**OPINION No 18/2019  
OF THE EUROPEAN UNION AGENCY  
FOR THE COOPERATION OF ENERGY REGULATORS**

**of 25 September 2019**

**ON THE DRAFT REGIONAL LISTS OF  
PROPOSED ELECTRICITY PROJECTS OF COMMON INTEREST 2019**

Figure 1: NRAs assessments regarding inconsistencies to the data

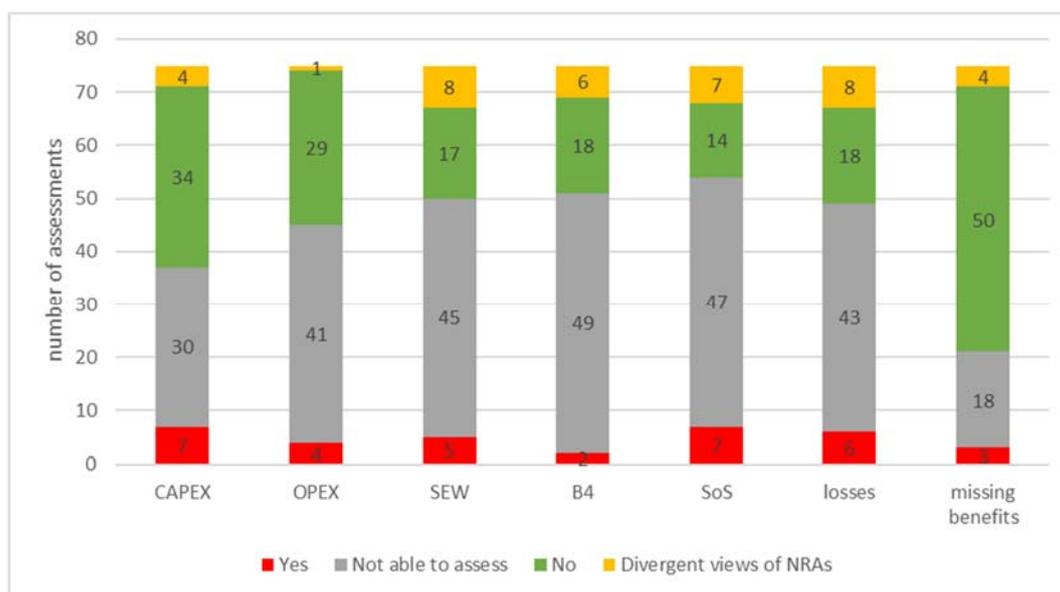
The statistics regarding the identification of inconsistencies to the data and calculations included in the TYNDP 2018 regarding the projects’ CAPEX and OPEX, the benefit calculations and the “missing/alternative benefits” are presented in figure 1 below.
